LOS ALTOS HILLVIEW PARK & COMMUNITY CENTER

10/25/2014
AIA Community Charette

Design Team Concepts and Feedback

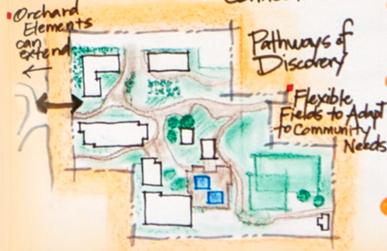
- Maintain Informality and Openness.
- Meandering Pathways contrast w/ hard lines of buildings
- Indoor + Outdoor Connections

- Maintaining ½ Acre of Orchard
- Love San Antonio Solution
- Extend Community Ctr to shield pool
- Add water features (Wildlife Friendly)
- Study moving Police facilities off site.
- Possible Round About
- Love Inter-Generational Possibilities of Different Uses.
- Rainwater Harvesting
- Permeable Pavers
- Expand Neutra House Features
- Right-Size Fields
